# North Dakota Department of Transportation

## ADDENDUM 2 – JOB 7

TO: All prospective bidders on Project SC-4718(060), Job No. 7 scheduled for the November 9, 2018 bid opening.

## ADDENUM 2 – JOB 7

Revised 10/24/18	STATE	PROJECT NO.	PCN	SECTION NO.	SHEET NO.
	ND	SC-4718(060)	22240	1	1

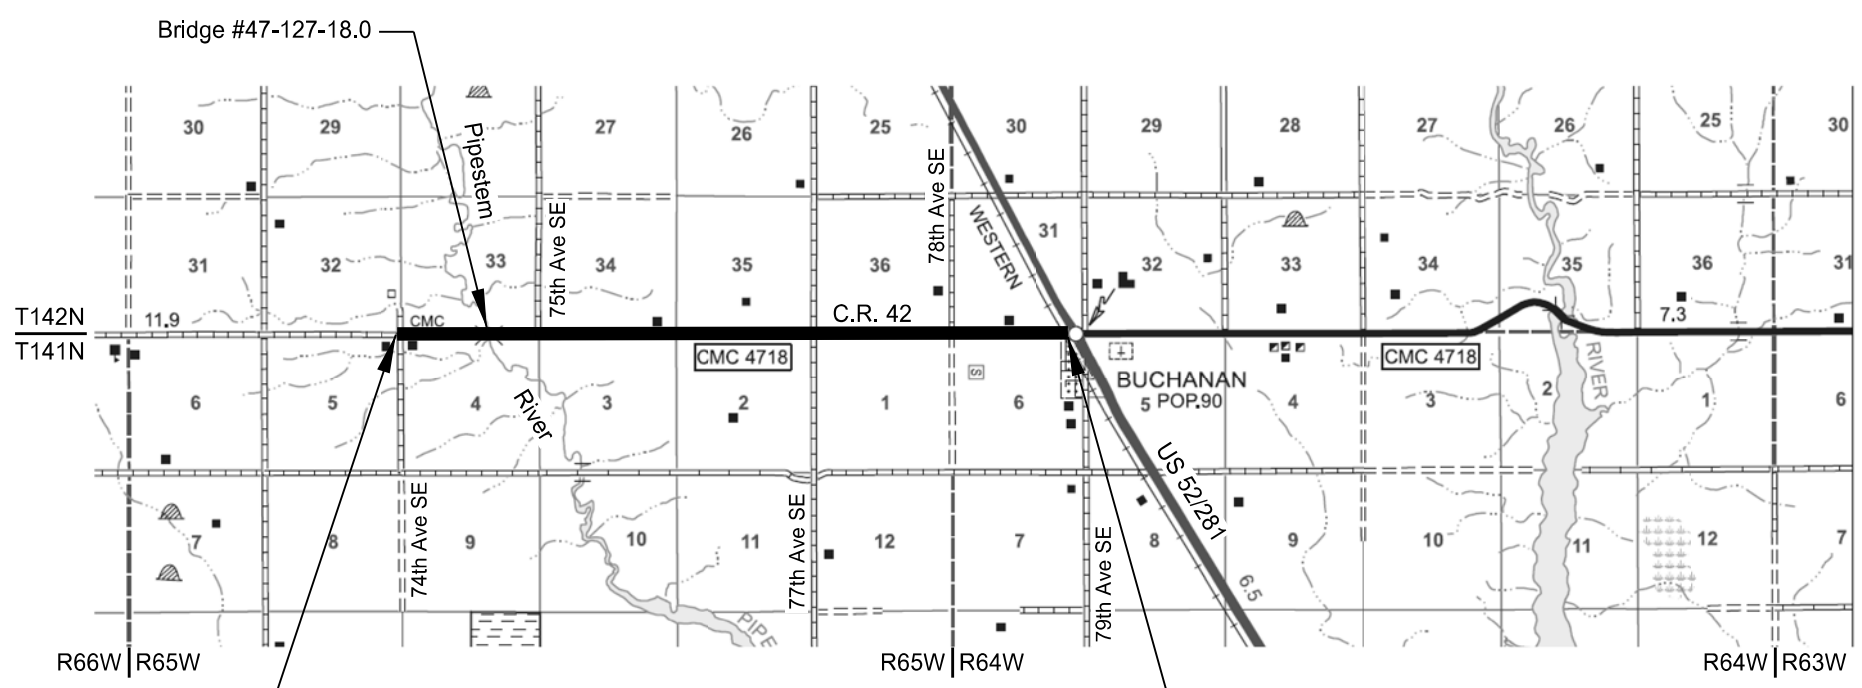
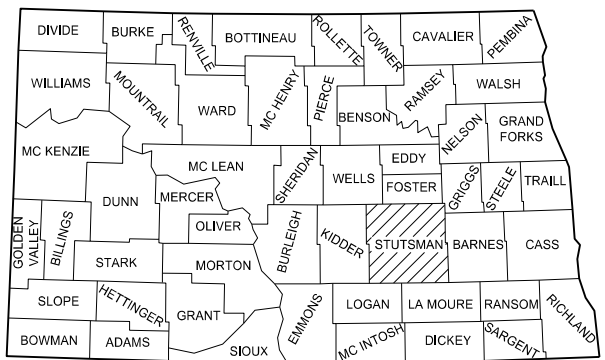
Updated title sheet to reflect guardrail work.

Revised	10/24/18	STATE	PROJECT NO.	SECTION NO.	SHEET NO.
		ND	SC-4718(060)	8	1

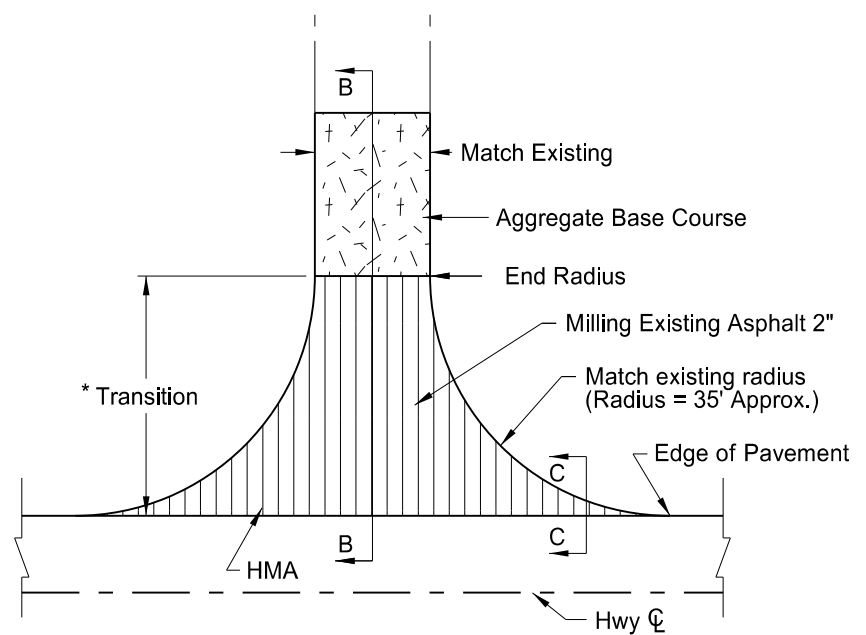
Updated additional quantities and changed from CL 3 aggregate to CL 13.

Updated basis of estimate for guard rail work.

TEMPORARY EROSION CONTROL  
 Co. Rd 42  
 Buchanan West Approximately 5 Miles  
 Stutsman County, North Dakota

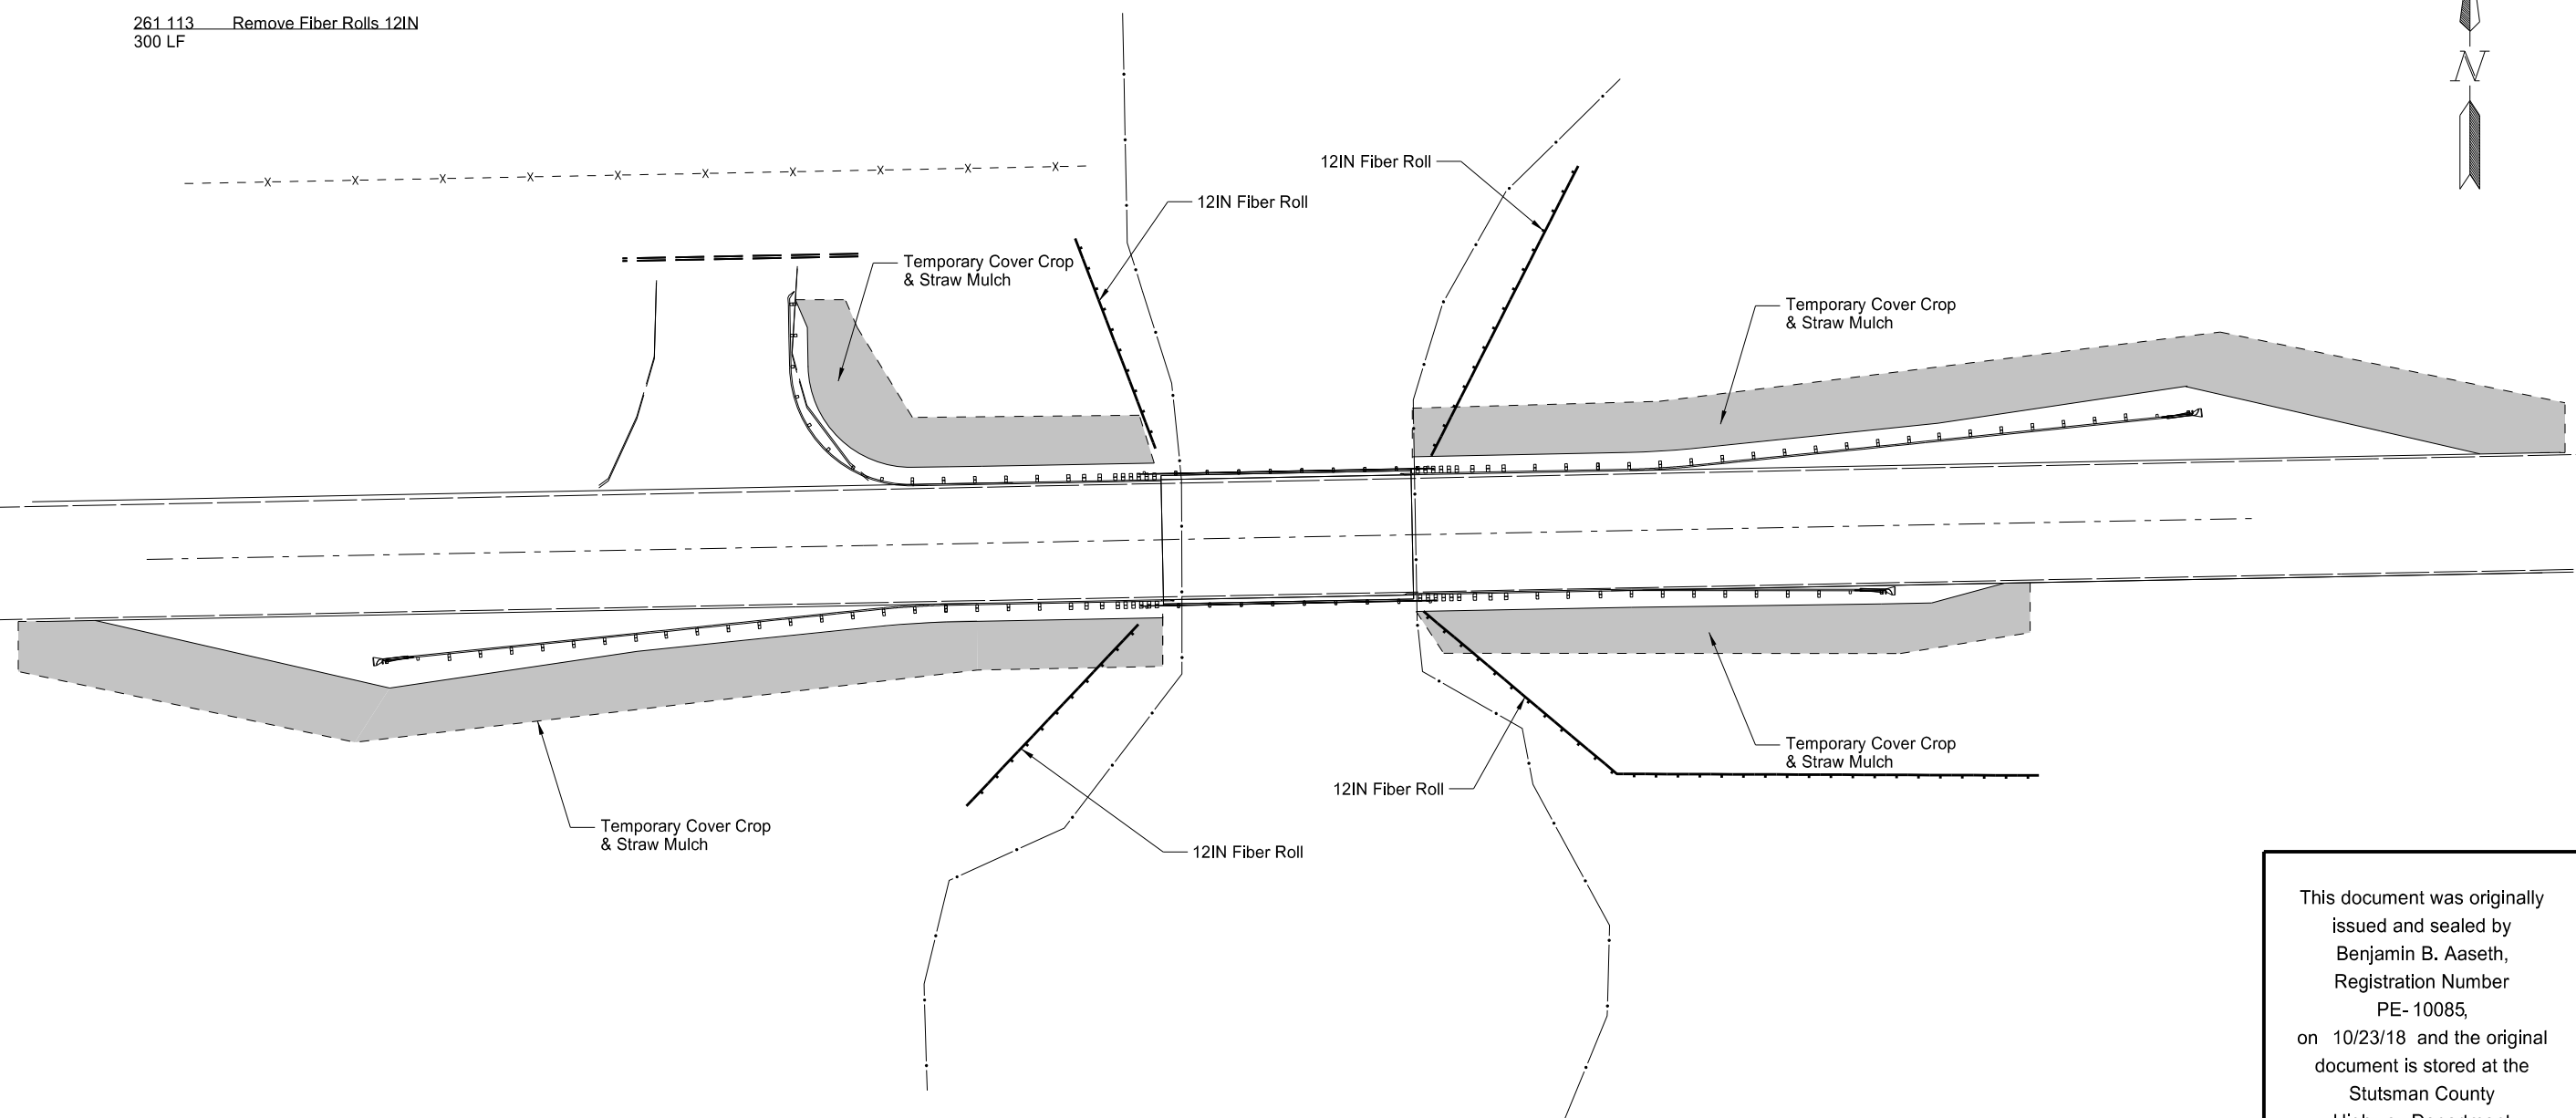
Added temporary erosion control layout.

PERMANENT EROSION CONTROL  
 Co. Rd. 42  
 Buchanan West Approximately 5 Miles  
 Stutsman County, North Dakota

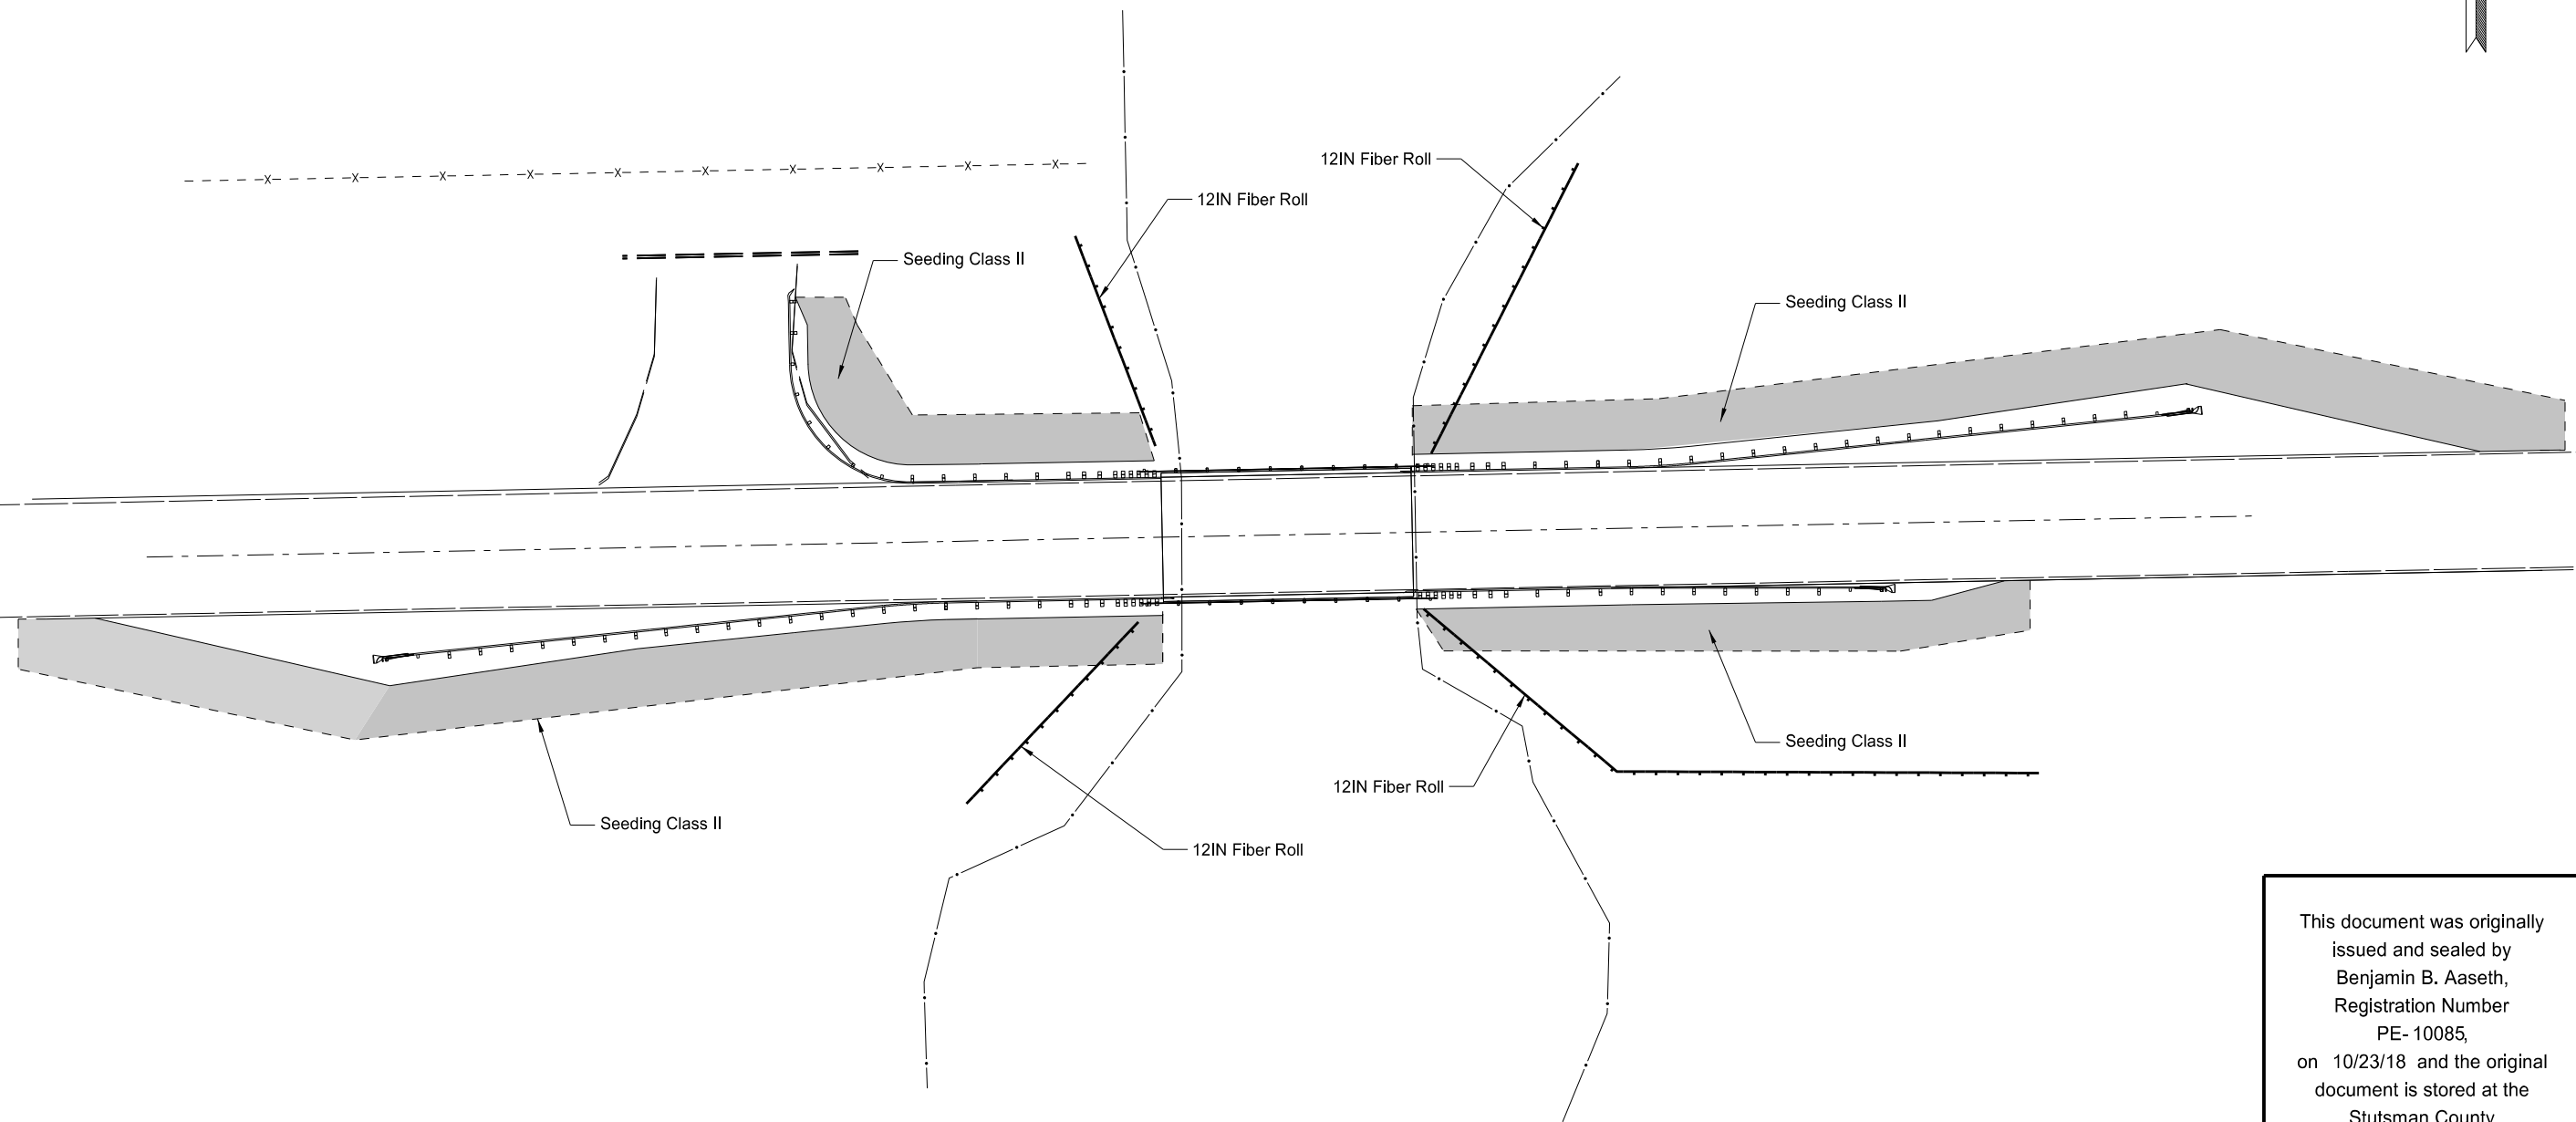
Added Permanent erosion control layout.
